Issue No. : BBHKN-23-00011-1
Issue Date : May 21, 2024

Change Notice : Change of LED chip & Wire Bonding Method for Photocouplers

◆Description of the change◆

Outline

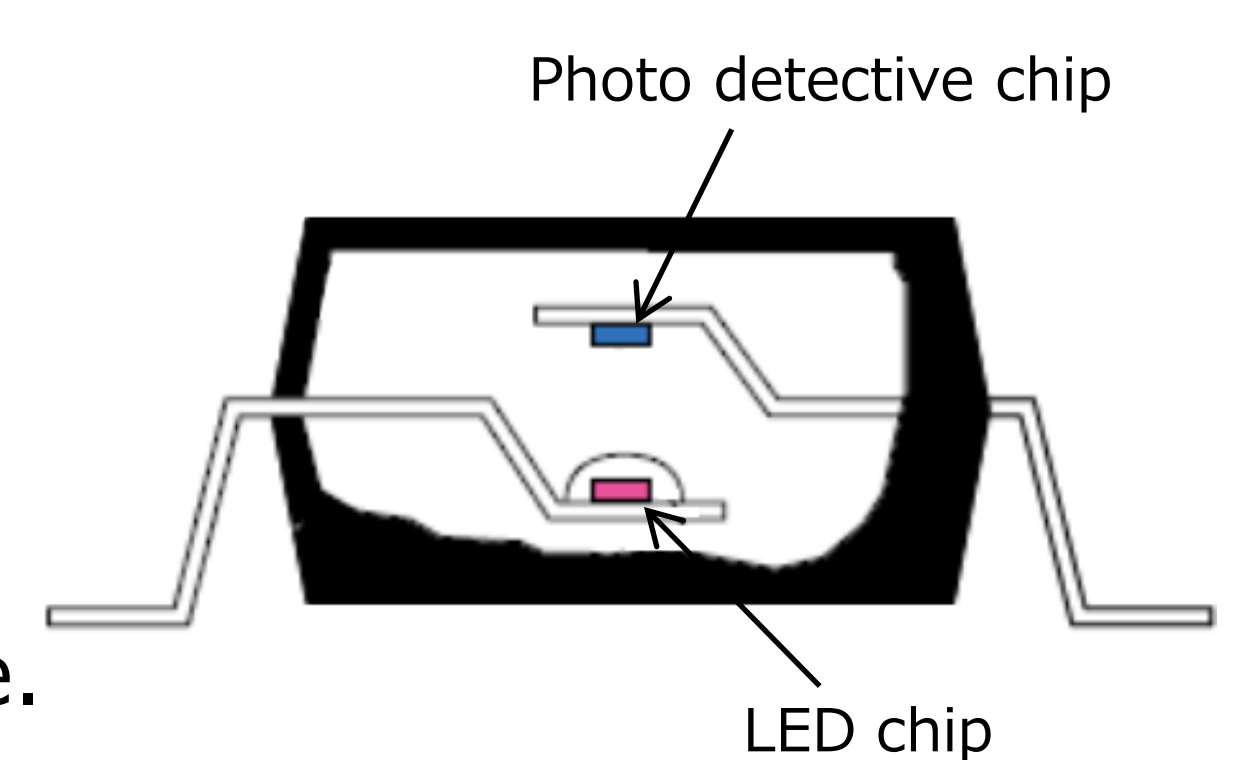
- **Affected Part Name:** Refer to the following page.
- **Change details:** Toshiba will change the LED chip mounted in our photocouplers to another LED chip that has been used in our different product type approximately hundreds of millions of pieces for the past 10 years. The chip shows equivalent characteristics before and after the change.
- **Reason for change:** The current LED chip uses a material that has difficulties in substitutability and availability. Toshiba therefore change it to an alternative LED chip that does not use the material.
- **Schedule:** We plan to switch it from the production in December 2024.
- **Appearance of the LED chip before and after the change**

Before change	After change
Top view	200	200
Side view	130	115

Outline

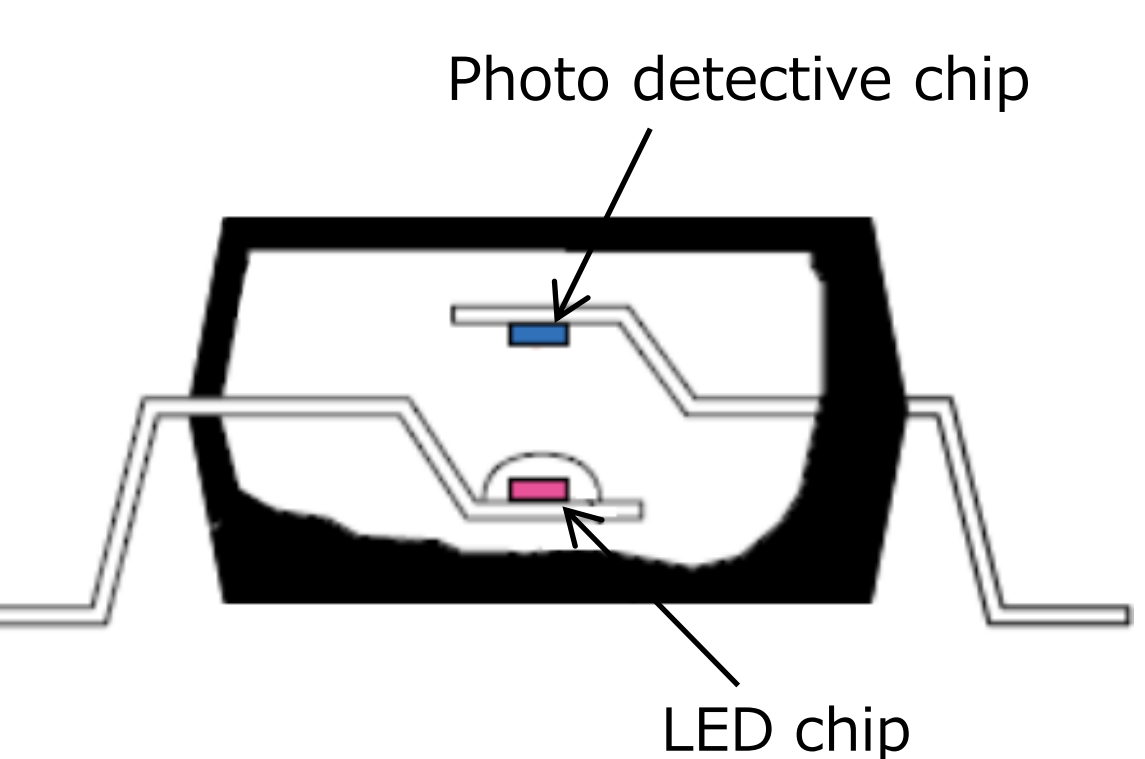
1. Toshiba will change the LED chip mounted in our photocouplers to another LED chip that has been used in our different product type approximately hundreds of millions of pieces for the past 10 years.
   The chip shows equivalent characteristics before and after the change.
2. We also change the wire bonding method to the one for other product type with the same package to unify the bonding condition.

1. The current LED chip uses a material that has difficulties in substitutability and availability.
   Toshiba therefore change it to an alternative LED chip that does not use the material.
2. For the change of wire bonding method, we will unify the bonding method to the one for other product type using the same package and the same type of LED chip (e.g. TLP5212), aiming to simplify the process control.

Appearance of the LED chip before and after the change

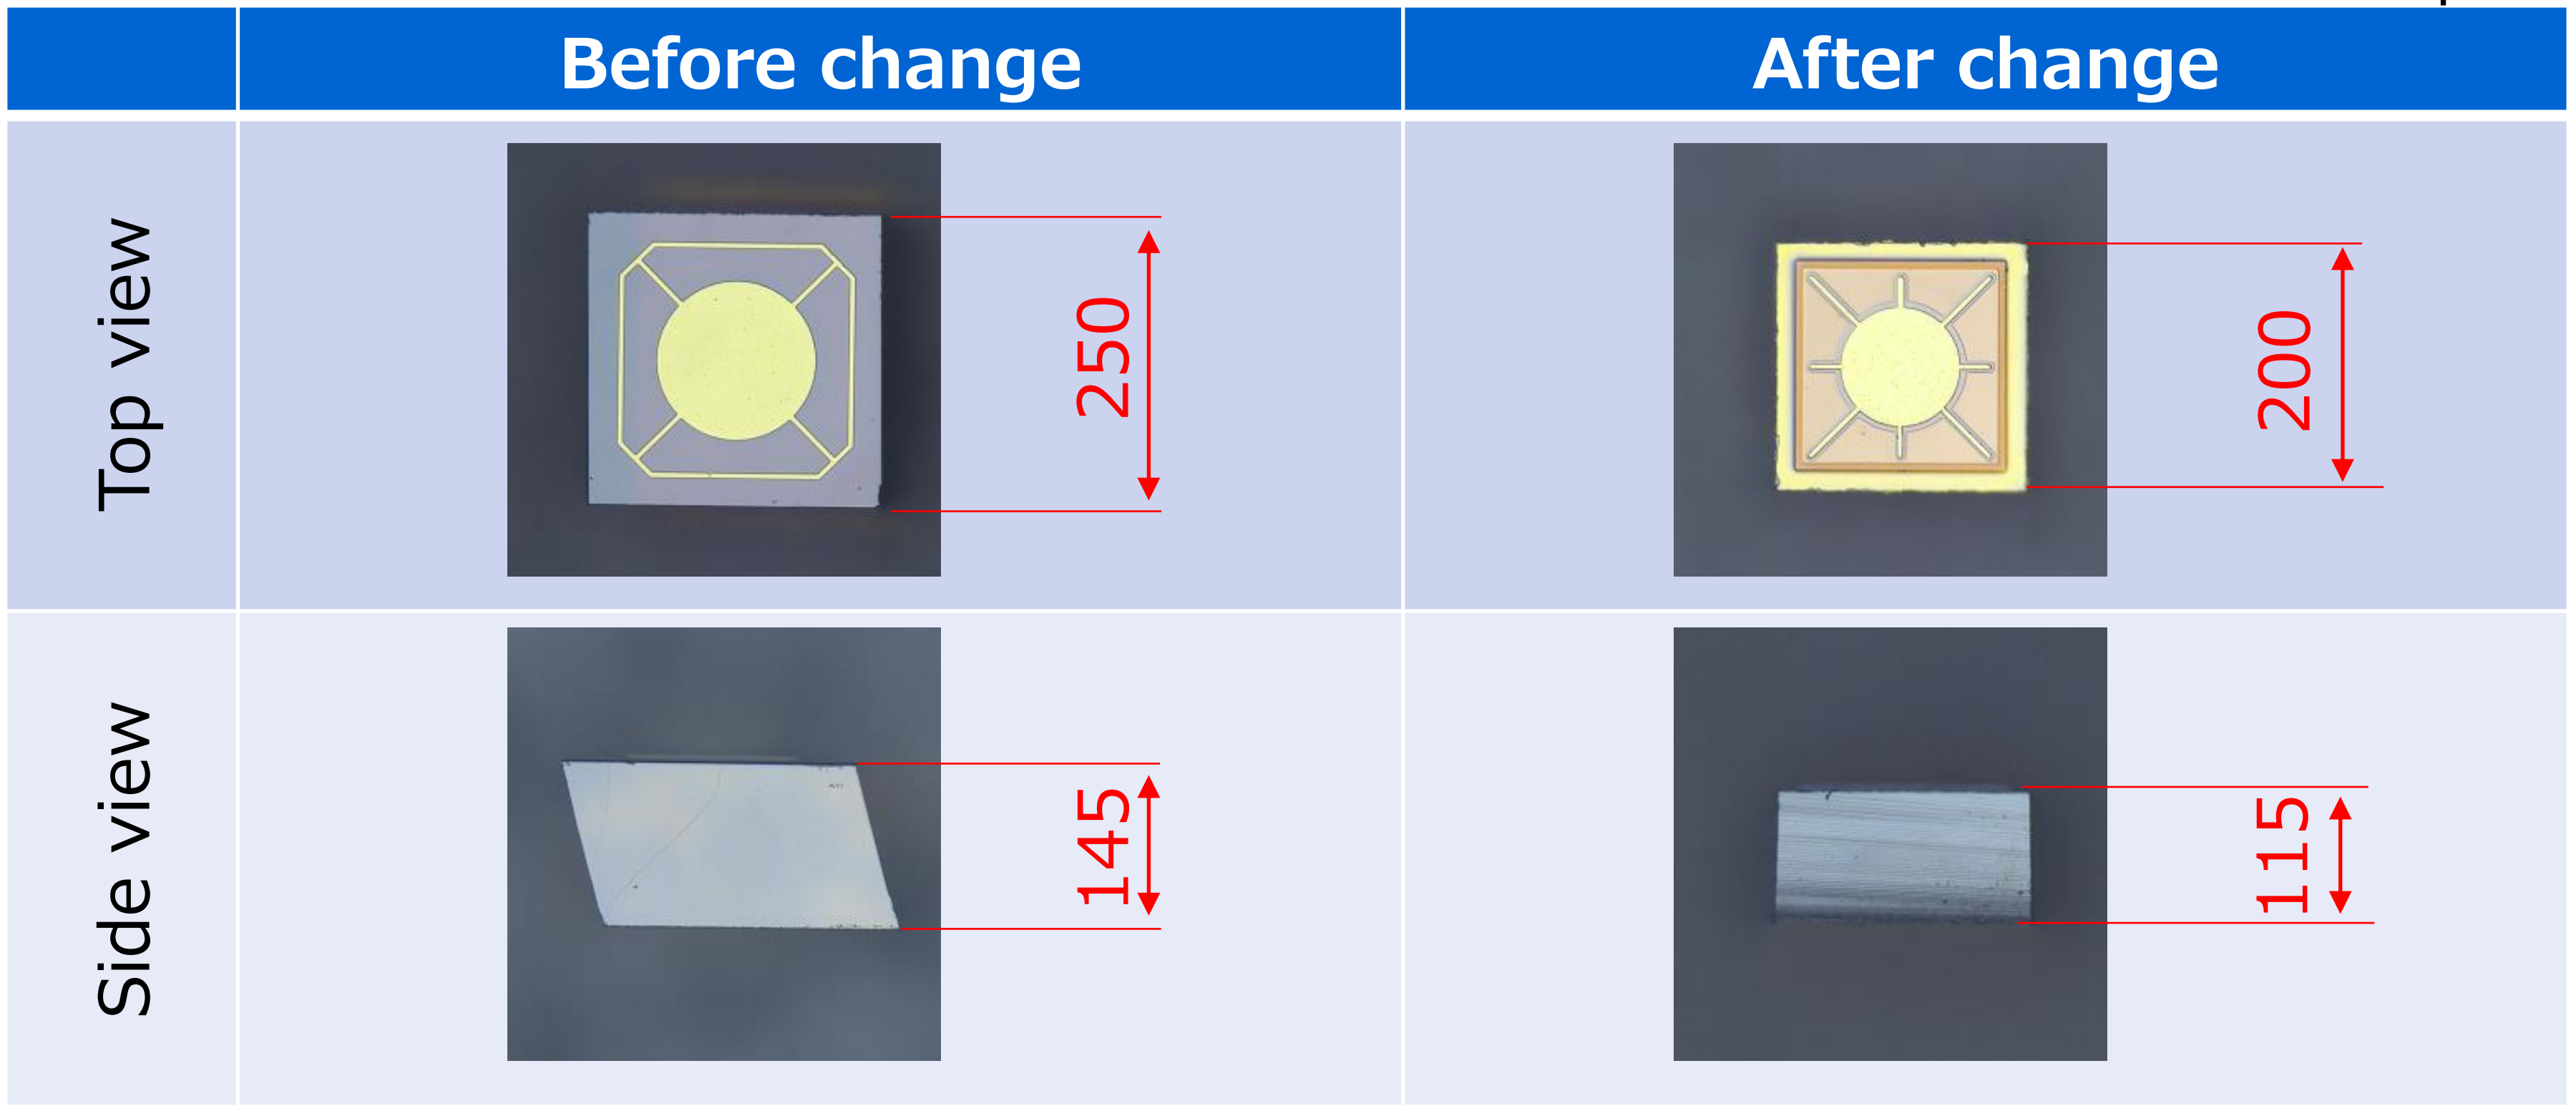
The LED chip to be changed has already been used in our photocouplers, and is a proven one.

Wire bonding method

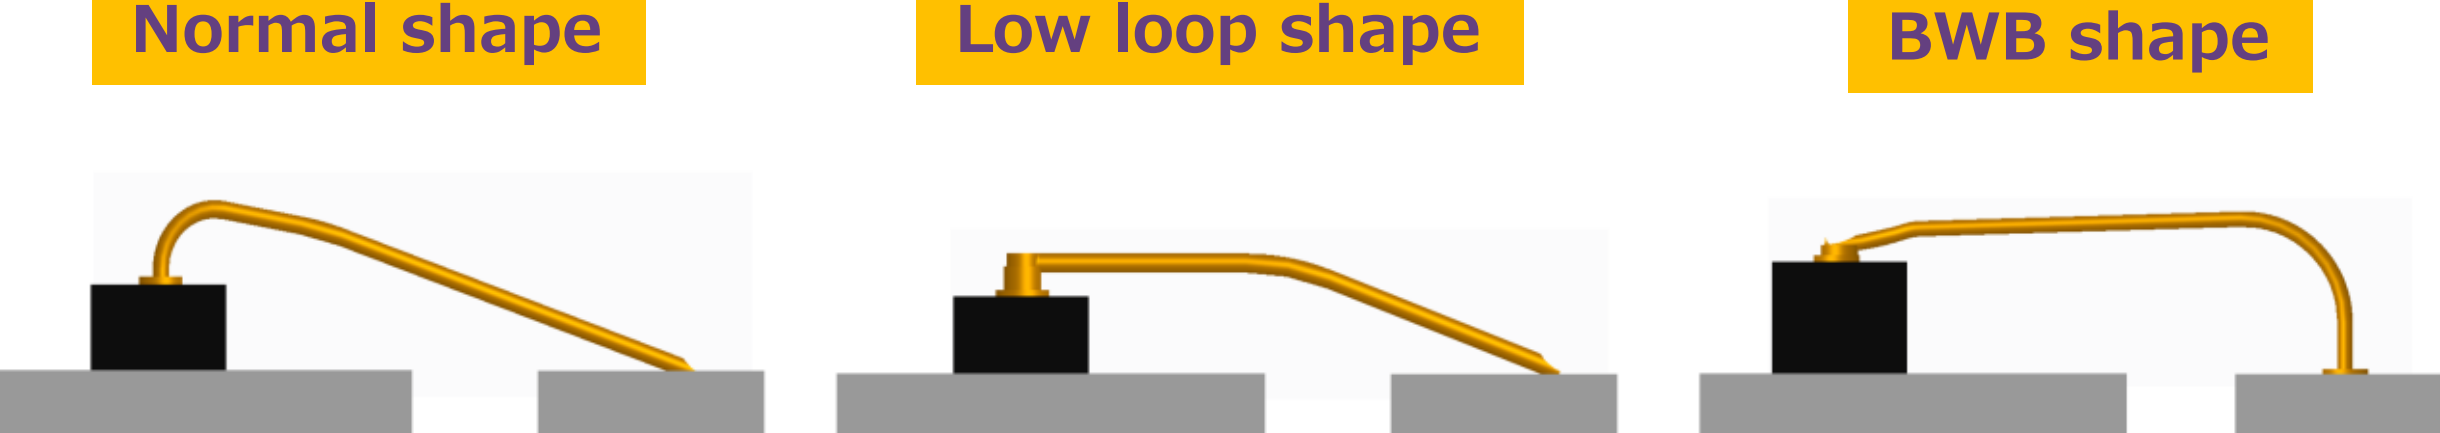
We will unify the bonding method to the one for other product type using the same package and the same type of LED chip, aiming to simplify the process control.

Frame position		Before change	After change
LED side	Transmitter LED	Low loop	**Normal**
	Feedback IC	Mixed loop (Normal & Low loop)	**BWB**
Photo detector side	Driver IC	Normal	**BWB**
	Feedback LED	Low loop	**Normal**

Comparison of before/after the change

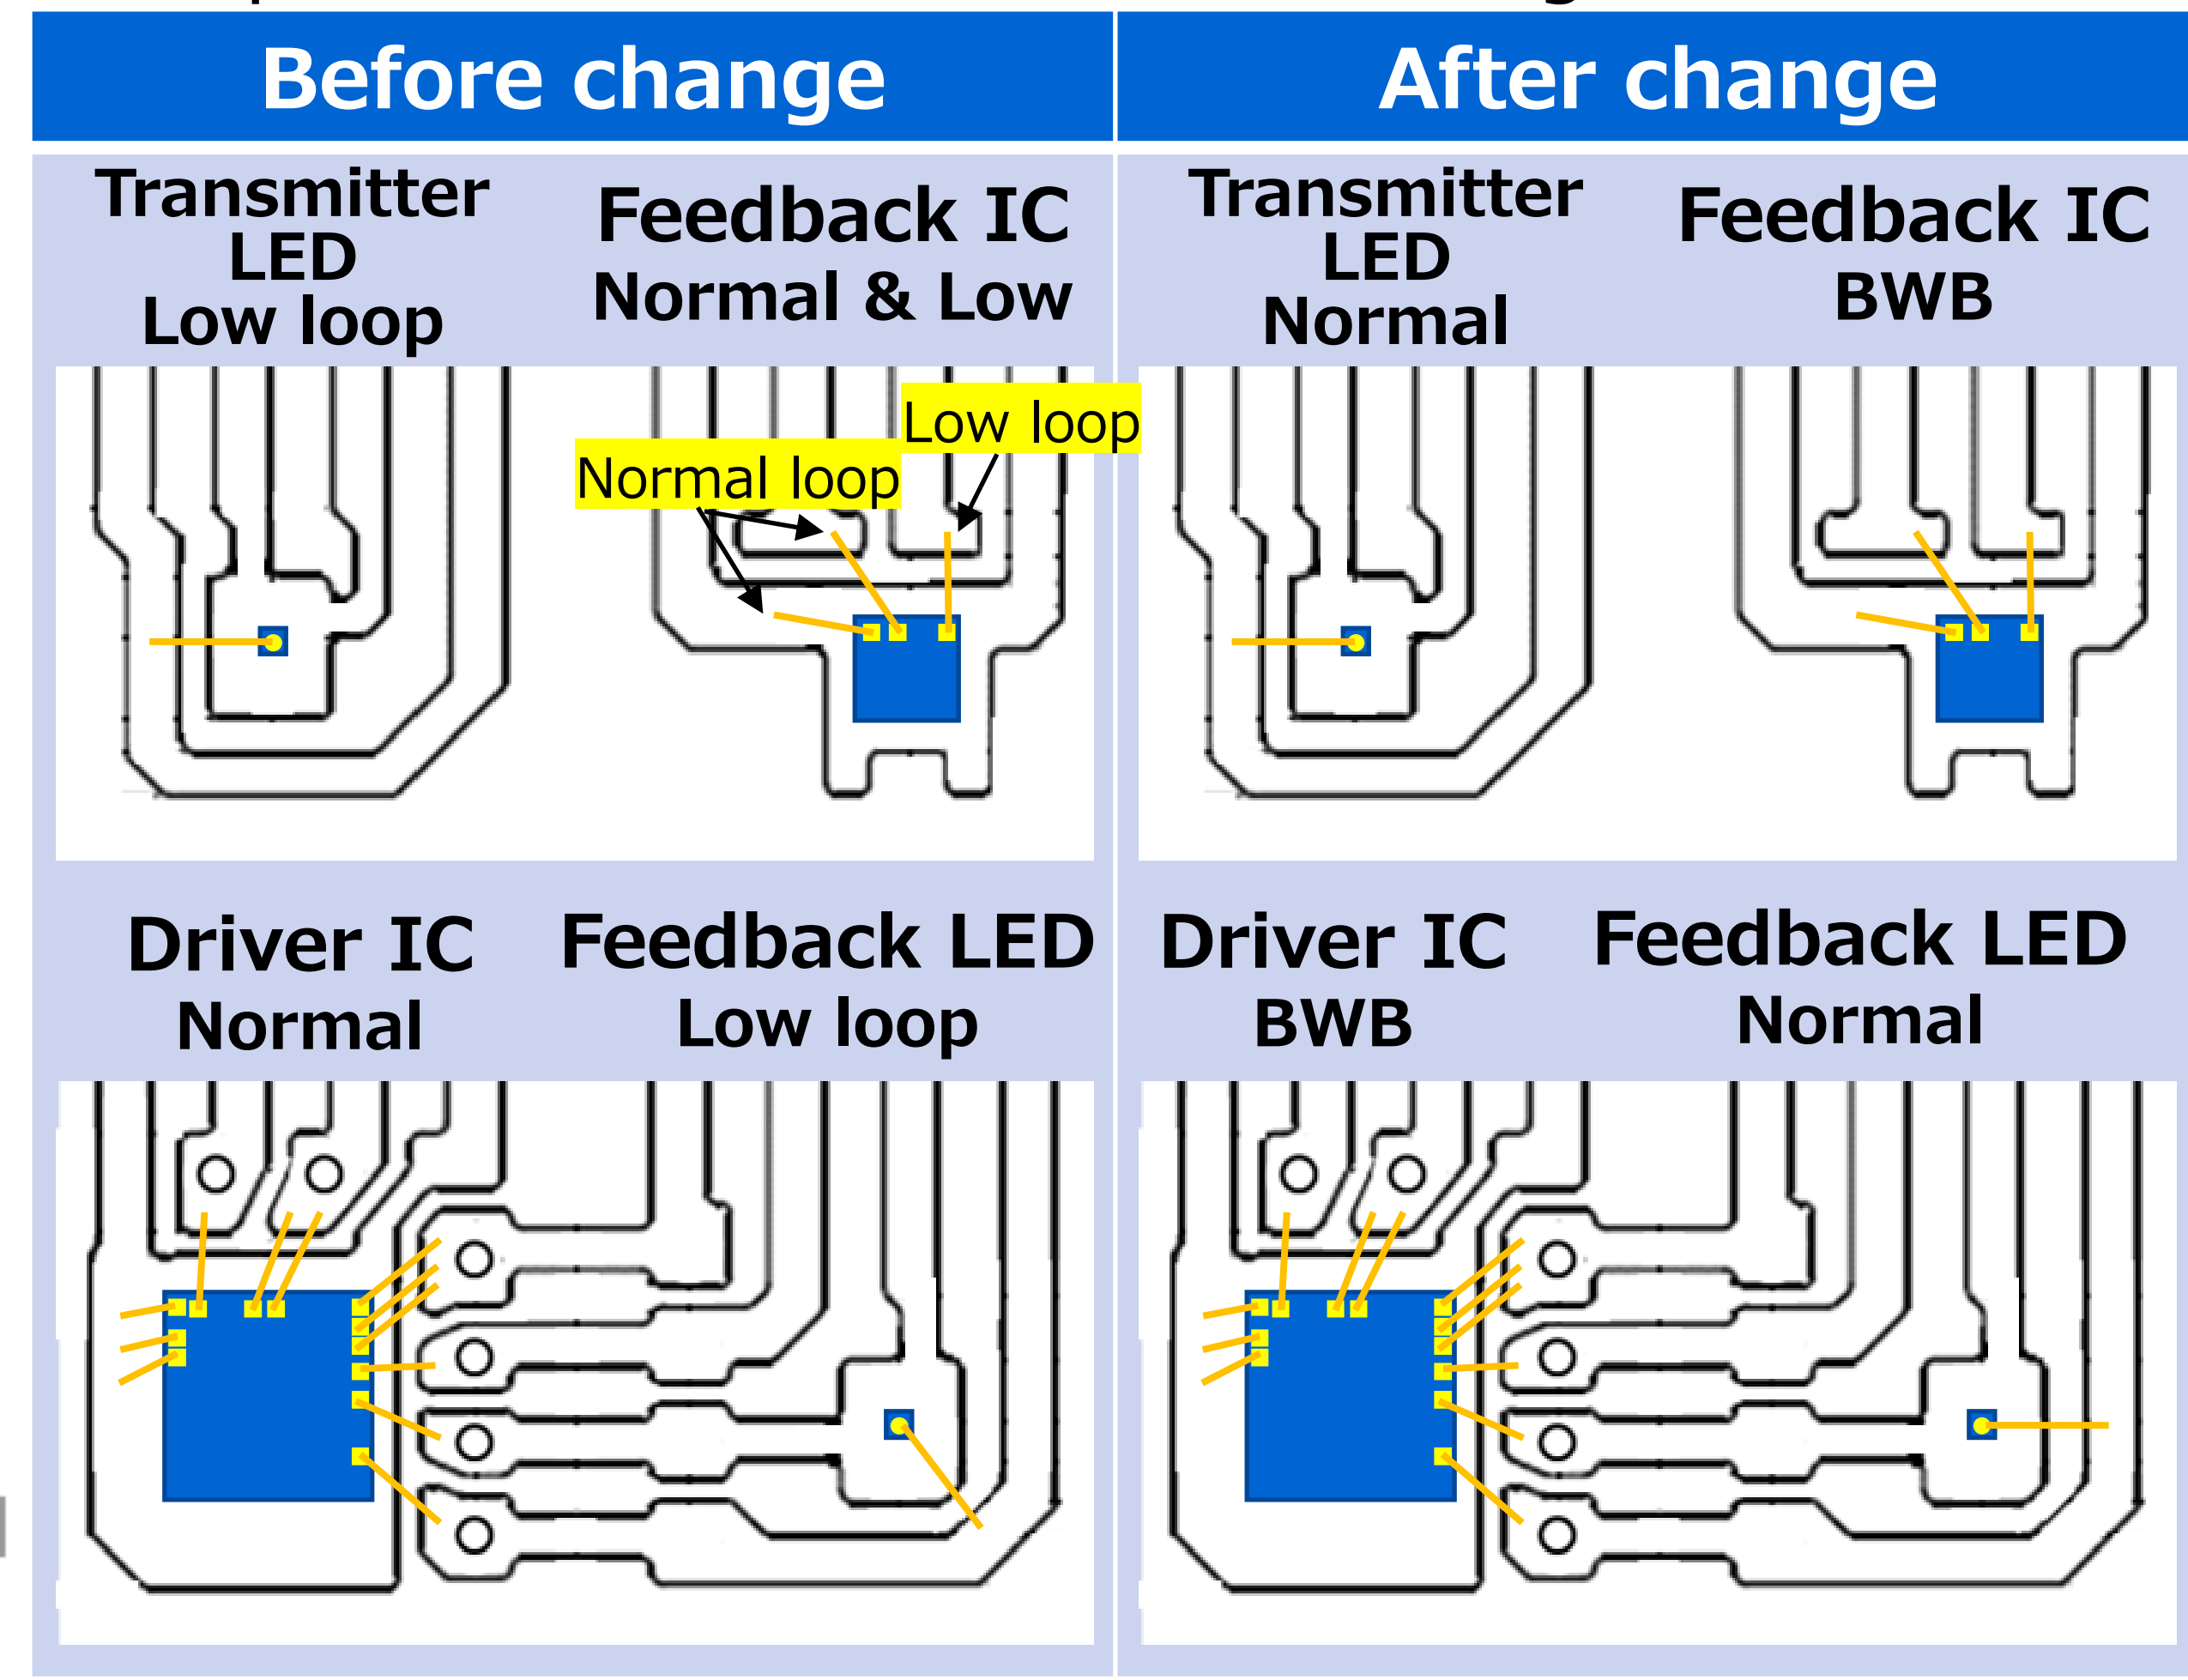
*To secure isolation margins, the wire bonding position of Feedback LED will be changed.
